Florida Department of Transportation

SUBJECT: Temporary Design Bulletin C06-01
Design & Load Rating Bridges

REVISIONS TO
"MANUAL FOR CONDITION
EVALUATION AND LOAD AND
RESISTANCE FACTOR RATING (LRFR)
WITH 2005 INTERIM"

FDOT Figure 6-1, Flowchart for Load Rating

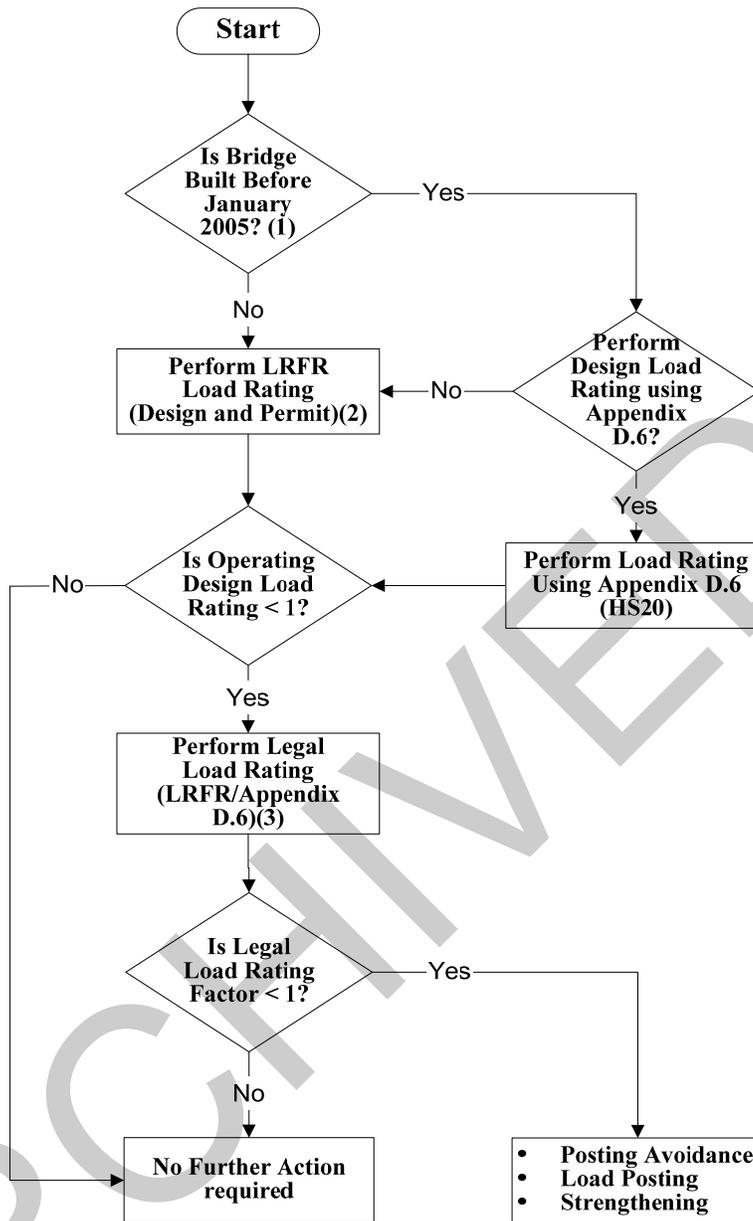
Replace Figure 6-1, Flow Chart for Load Rating, with FDOT Figure 6-1.

The routine FDOT rating process is shown in FDOT Figure 6-1.

Rate bridges designed January 2005 and after using LRFR. For bridges designed before January 2005, use Appendix D.6 for rating. For bridges designed using the LFD methodology before January 2005, LRFR may be used as an alternative.

Figure 6-3

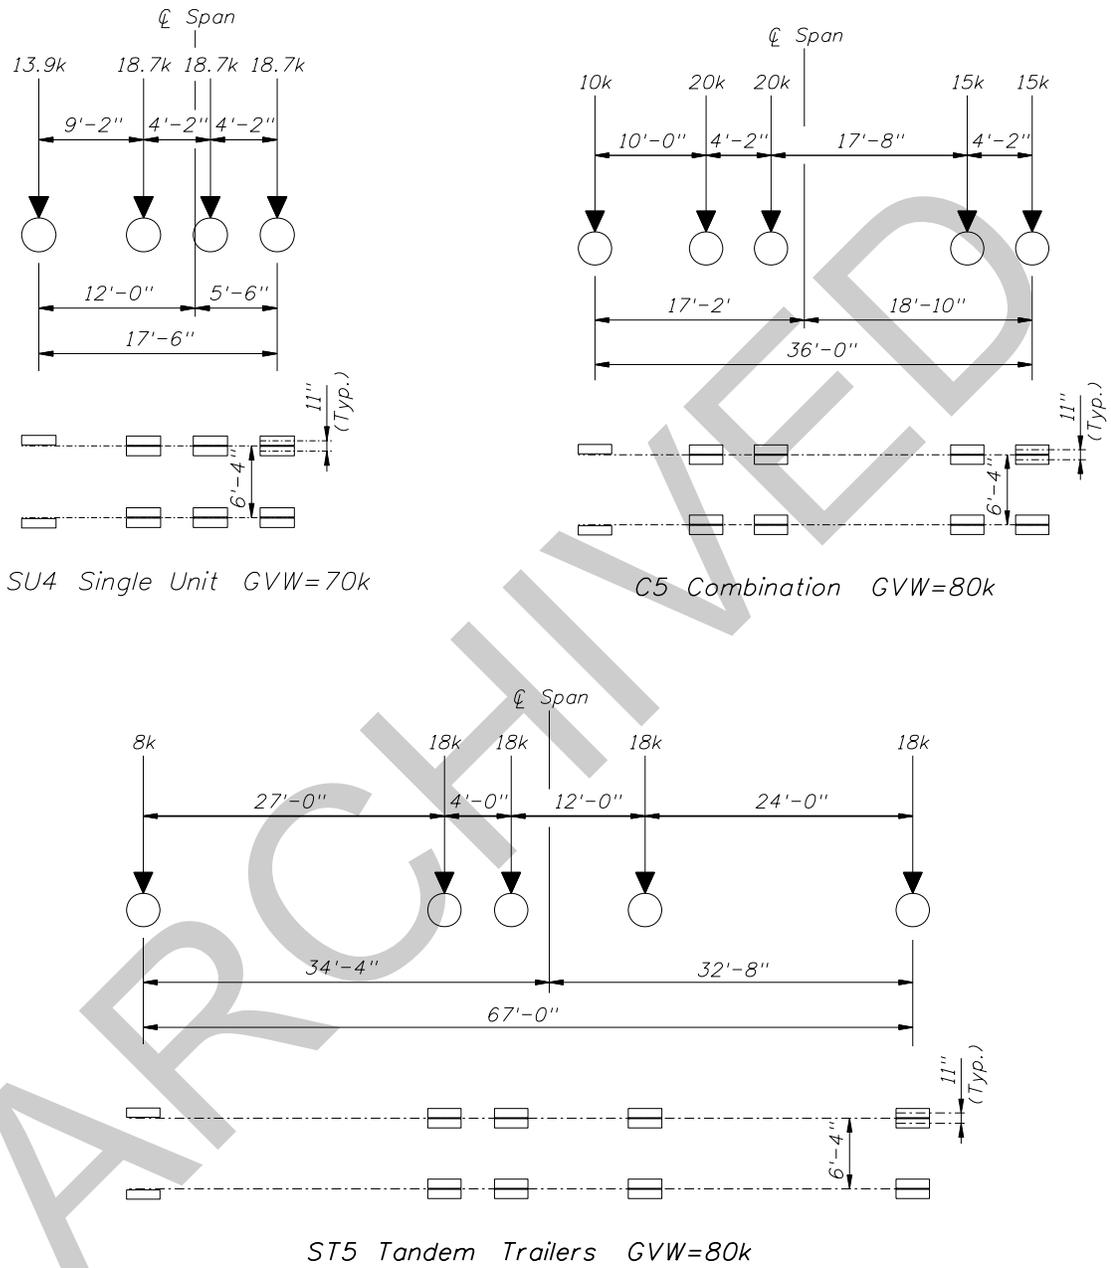
Replace this article with the following:

Use the SU4, C5, and ST5 Florida legal loads defined in Figure 6-3 for legal load rating. Assume the SU4, C5, and ST5 trucks are in each loaded lane; do not mix trucks.
